## Comment Letters

### Introduction and Index

This section of the RAB Documents Page contains 20 examples of comment letters written by citizen members of the Restoration Advisory Board between 1996 and 2013. The letters concern the environmental cleanup, or remediation, of the Presidio, a 1,491-acre Army base that became a national park in 1994. Some of these letters are cited in the Presidio of San Francisco Restoration Advisory Board Final Report, which can be found at this link: [Final Report](#)

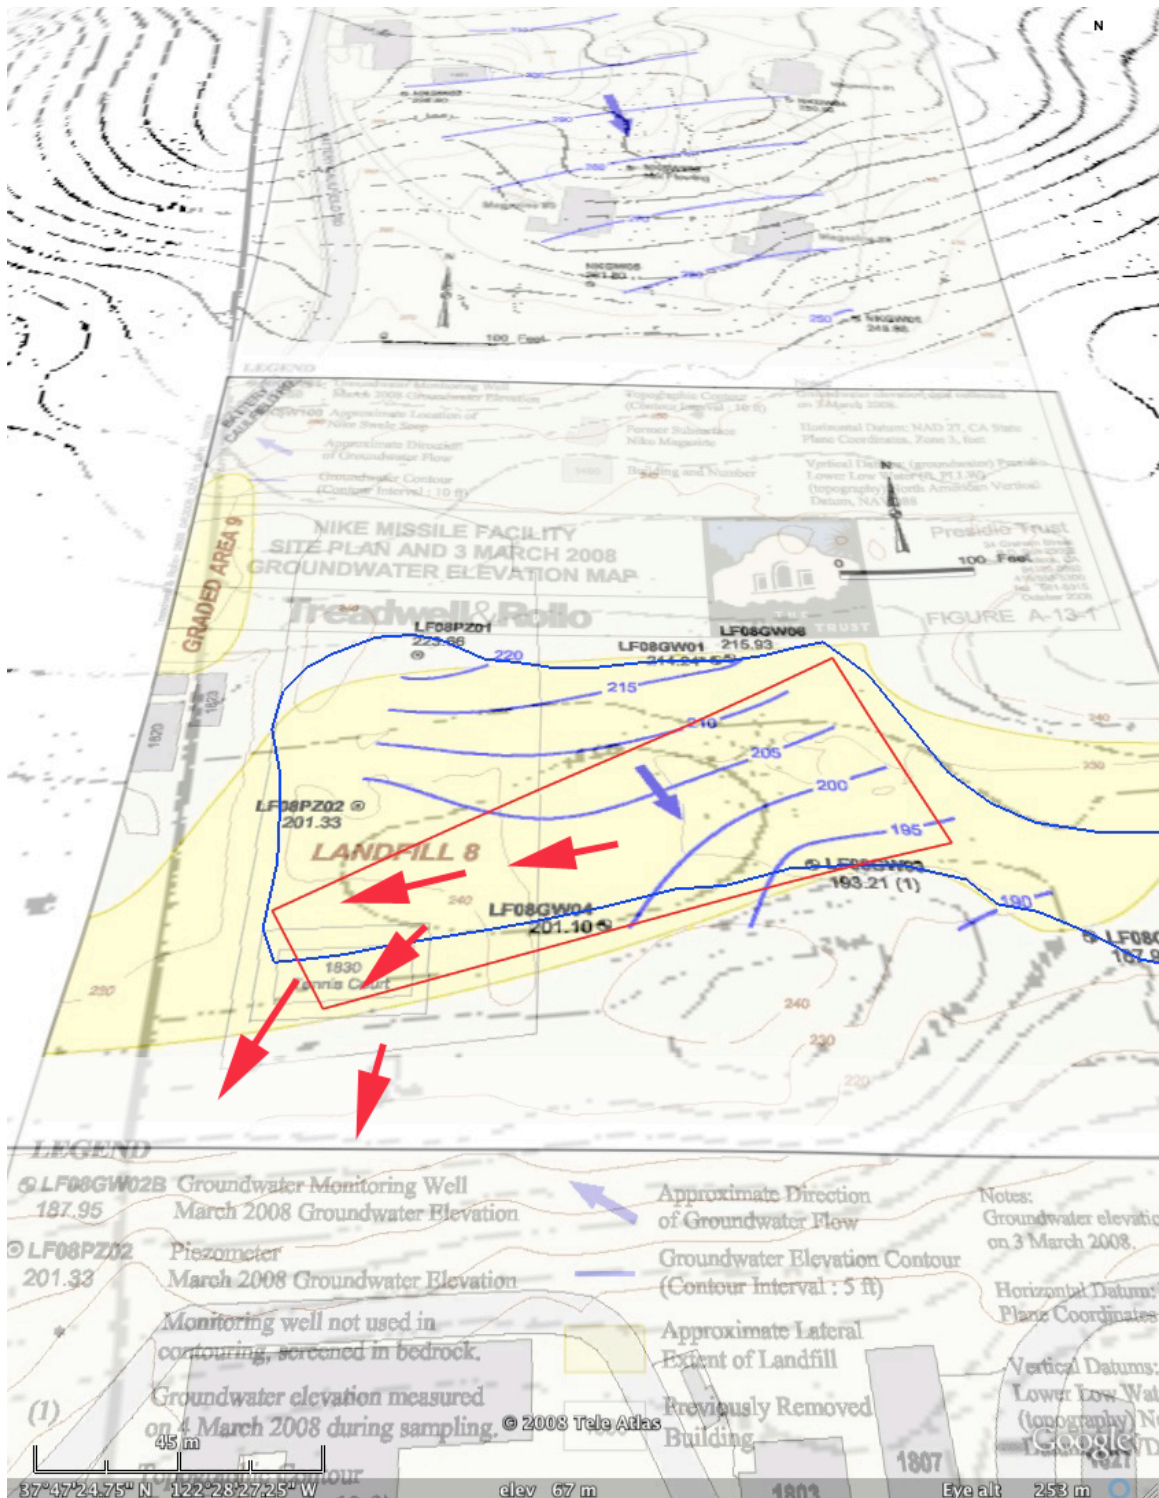
See Figure 1 below.

As Table 3 below demonstrates there is a considerable thickness of Colma Formation between the top of the Colma and the tops of most of the groundwater well screened intervals at Landfill 8, except in the case of GW04 where water passing through most of the fill material is diverted to the west without being sampled at GW04.

**Figure 6: Highway 1 Stormwater Management Elements**

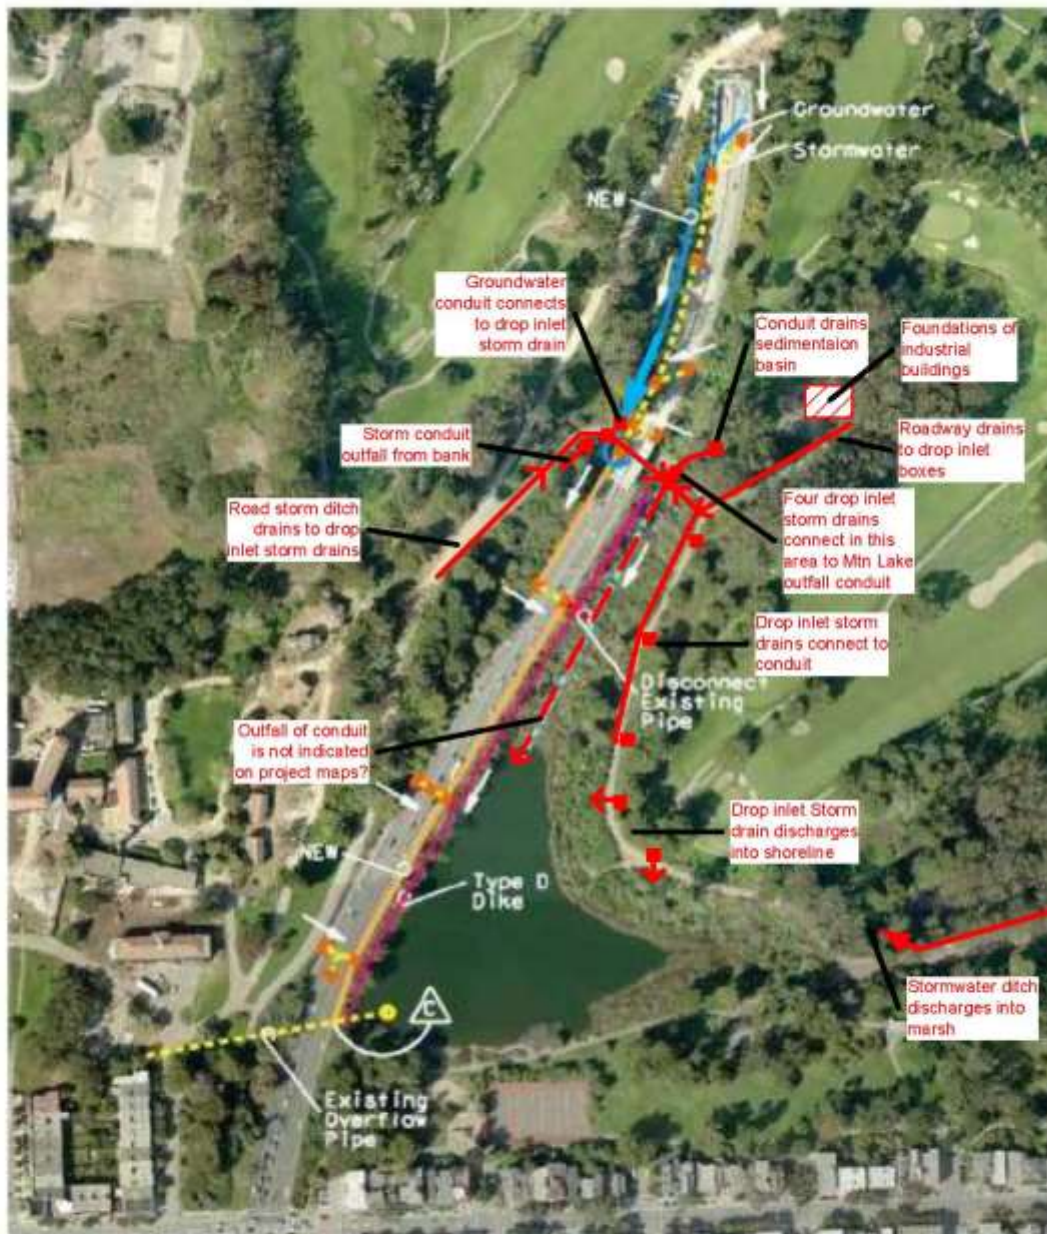
Comment: Figure 6 depicts separate systems for groundwater and stormwater. Groundwater from the Highway 1 tunnel is conveyed by conduit to the north end of the lake (blue line). However, the groundwater flow (blue line) is incorrectly shown on the figure. My field inspection indicates that the groundwater conduit joins a network of four drop inlet storm drains beneath Park Presidio Blvd. These storm drains are not apparent on this figure. Other drop inlet storm drains along the Mtn. Lake perimeter road also connect to this storm drain network. I understand this perimeter road was heavily patrolled by the Army for many decades. It appears that this drainage system at the north end of the lake is designed for sizeable water flows and may include overflow storm water from the Highway 1 above. There is also a stormwater conduit to what may be a Highway 1 sedimentation pond. This storm water system is not shown on project maps.

Original of this figure shows groundwater from Hwy 1 tunnel draining by conduit directly to Mtn. Lake with no stormwater inputs. This is incorrect. A significant network of drop inlet boxes, roadway ditches, and a sedimentation basin (adjacent to the Hwy 1 roadway) discharge into Mtn. Lake through this groundwater conduit. The Mtn. Lake outfall is shown as uncertain with no location indicated on project maps.

**Figure 35**  
**USACE Potential Jurisdictional Wetlands**  
**at Mountain Lake**

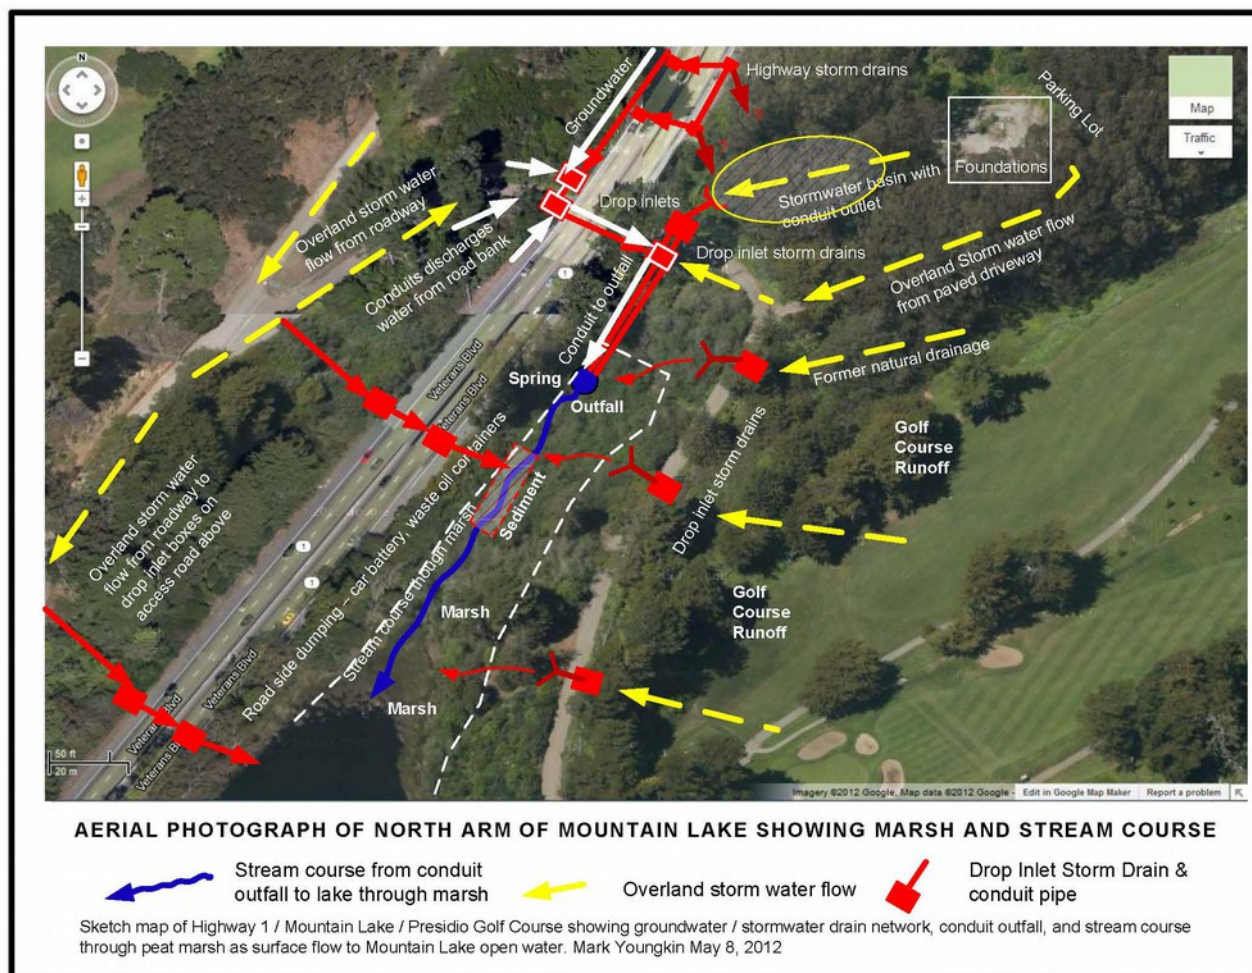
- COC / confirmation sampling should be expanded to include most widespread metal contaminants / pesticides in lake sediments.
- The RAP contains a vague contingency clause for determination of a “site specific release” during dredging / confirmation sampling.

- Map provided by Caltrans for storm drain network is inaccurate and misleading. Significant storm drain outfalls have not been sampled.
